STATE OF CONNECTICUT
CONNECTICUT SITING COUNCIL

RE: **PETITION NO. 1397** - Constitution Solar, LLC declaratory ruling, pursuant to Connecticut General Statutes §4-176 and §16-50k, for the proposed construction, maintenance and operation of a 20-megawatt AC solar photovoltaic electric generating facility on approximately 149 acres comprised of four separate parcels located off of Cornell Road in Plainfield, Connecticut and associated electrical interconnection.

Petition No. 1397
Constitution Solar, LLC
Cornell Road, Plainfield
Development & Management Plan
Staff Report
March 11, 2021

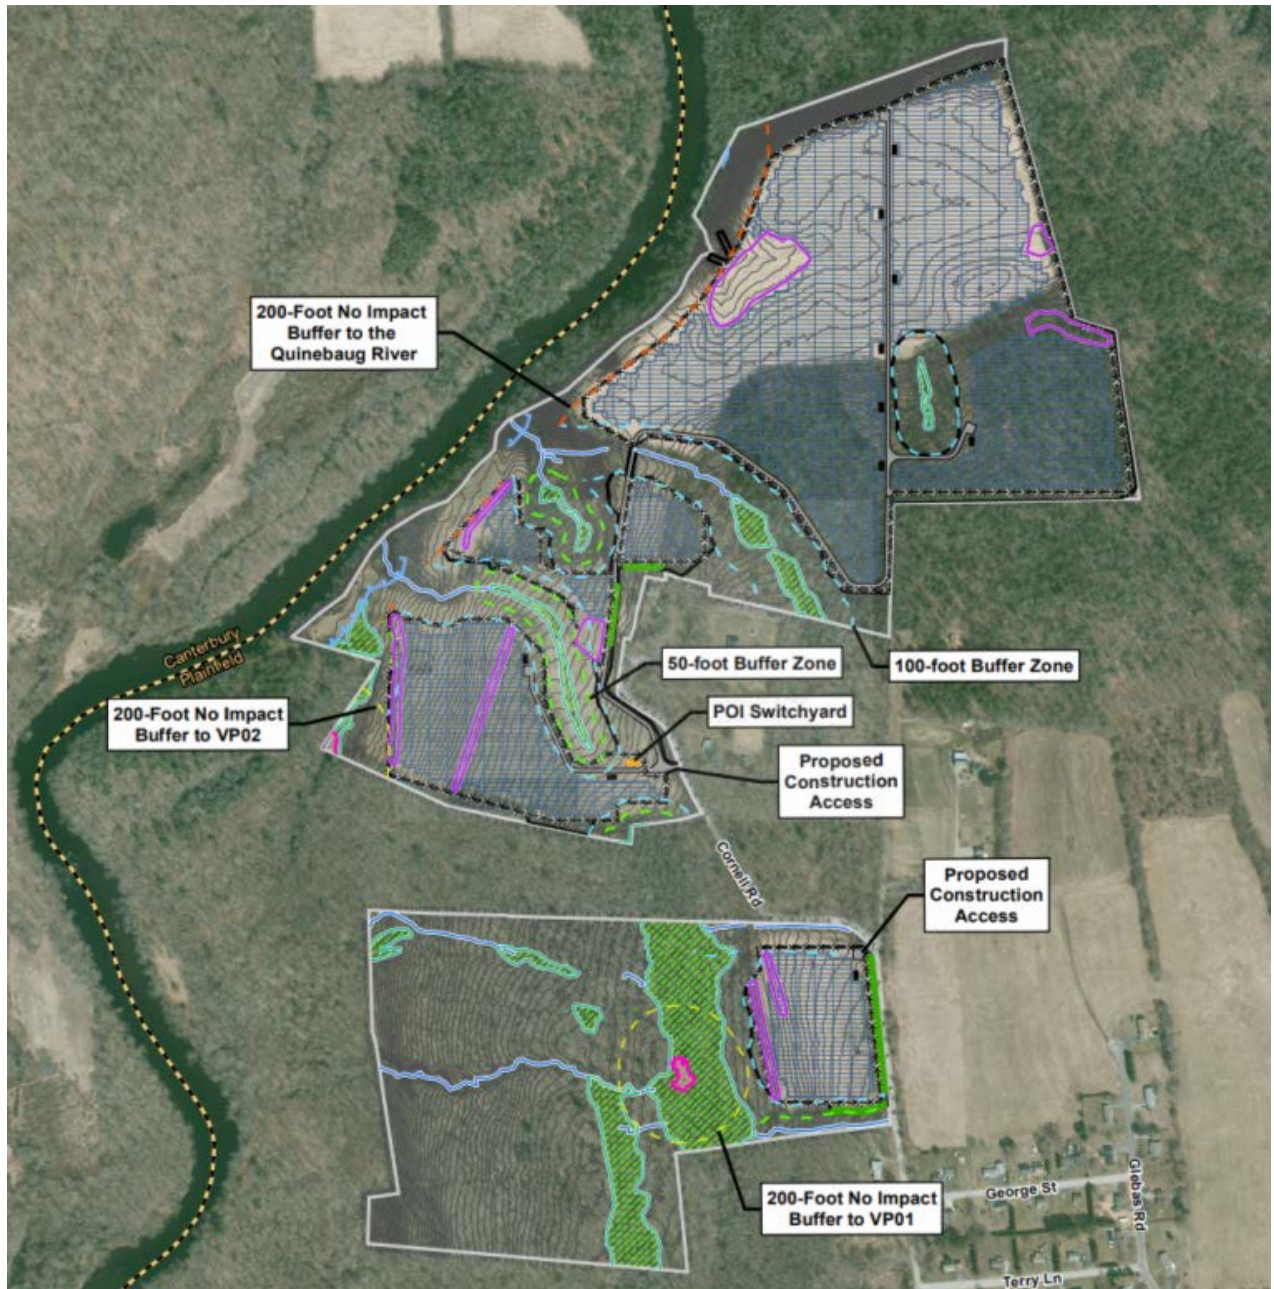
- 4. Install perimeter fencing with a six-inch gap between the ground and the bottom of the fence, except adjacent to site access gates and around the switchyard and other areas where enhanced security is necessary;**

Although the text of the D&M plan states the fence design would include a six-inch gap between the ground and the bottom of the fence where enhanced security is not necessary, the solar array fence detail shown on D&M Site Plan C-029 specifies a four-inch gap. If approved, Staff recommends CS to revise the fence design on Plan C-029.

1. Provide a copy of the DEEP Stormwater Permit authorization prior to the commencement of construction;
2. Provide the number of 475 Watt and 375 Watt panels to be installed at the site;
3. Revise and submit Site Plan Sheet C-029 Solar Array Fence detail to include a minimum six-inch gap between the ground and the bottom of the fence;
4. Incorporate native pollinator species into the post-construction site stabilization seed mix;
5. Provide an Operations and Maintenance Plan with inspection/maintenance protocols for site equipment, roads, fencing, solar field areas and stormwater management system; and
6. Provide contact information for the construction contractor.
